Upgrade Information of MPE720 Version 6.05

1.1 Ver.6.05 Upgrade Information

Items added and features improved from MPE720 Ver.6.04 to Ver.6.05 are as follows.

No.1 SGDV Servo Amplifier Selection Added to Module Configuration

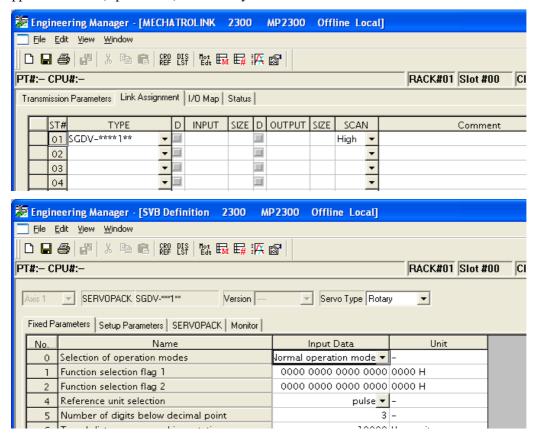
"SGDV-***1**" was added as a new servo amplifier for SVB module.

No.2 Motion Parameter Addition

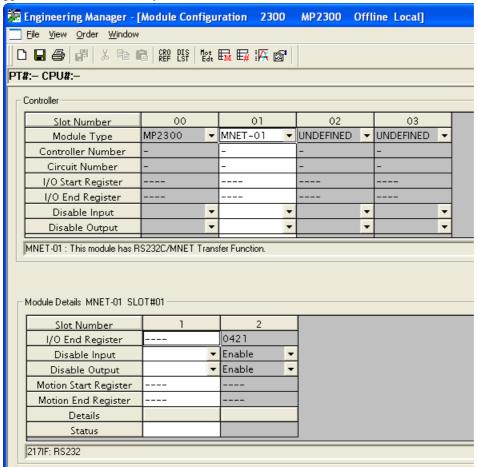
The following motion parameters were added for SGDV servo amplifier on the SVB module.

"Latch completion status clear request (OWxx00)", "Latch mode selection (OWxx01)", "Latch completion sequence number (IWxx44)" and "Number of continuous latch sequence completion cycles (IWxx45)" were added in "Continuous latch".

"Servo driver stop signal input (ILxx02)" and "Stop signal input(HWBB) (IWxx2E)" were added in "Hard wired base block".

No.4 "Phase Reference" Command Invalidation for MP2400

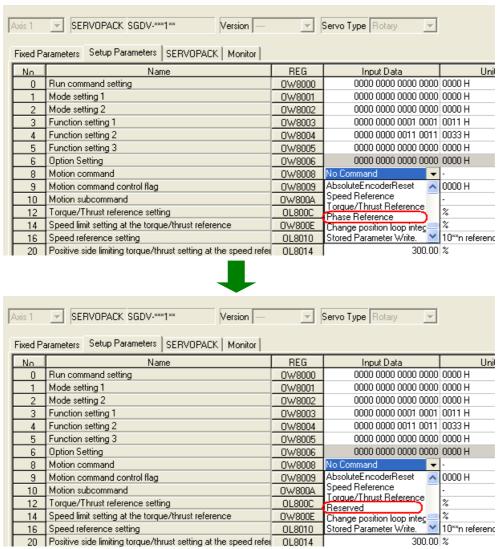
"Phase Reference" command was eliminated from the motion command for MP2400. It is invalid and displayed "Reserved".

No.6 Parameter "Pn000" for "SJDE-**AN*"

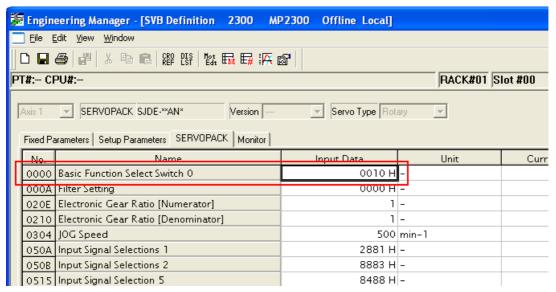
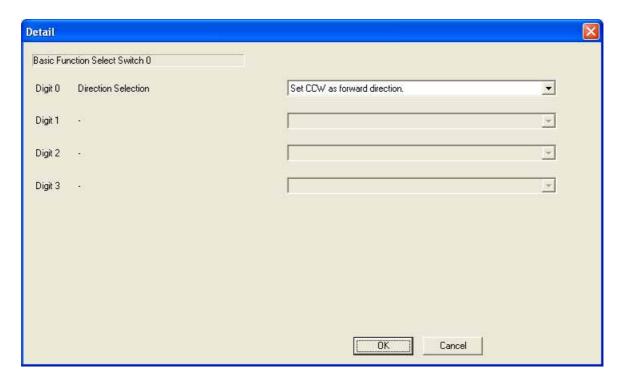
The user constant was added by support to "MECHATROLINK interface version JUNMA series servo amplifier" of MP2000 series SVB module (built-in CPU, option).

The parameter "Pn000" for "SJDE-**AN*" was added.

No.7 Group Definition of Sequence Program

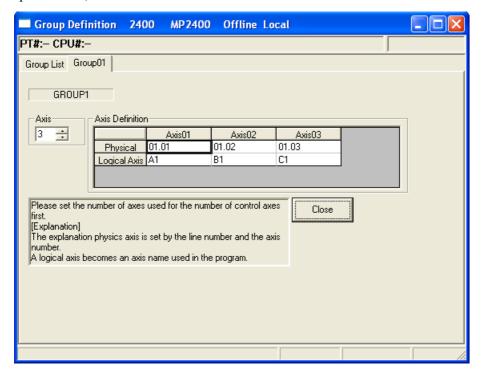
The following message dialog box appears to encourage group definition setup if Motion Command Assist dialog is operated in a sequence program.

No.8 Prohibit Duplicated Register Assignment in the User Structure

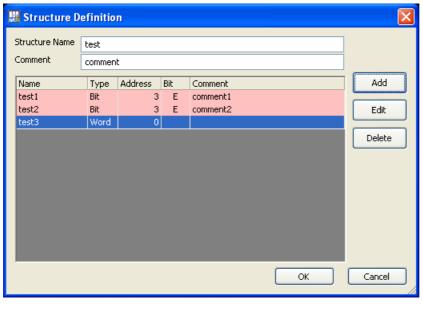
When there are members that have same data type, address, and bit address in a User Structure, they appear pink. The structure cannot be registered and an error dialog appears.

No.11 Modification of Display for CNTR-01 Module

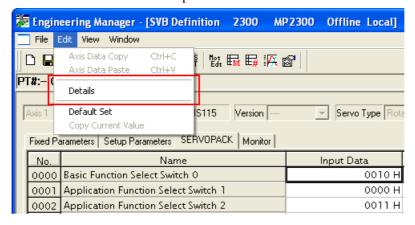
The displayed size of CNTR-01 module definition screen was improved to be appropriate to avoid hiding the setting area even if task manager or watch screen is displayed.
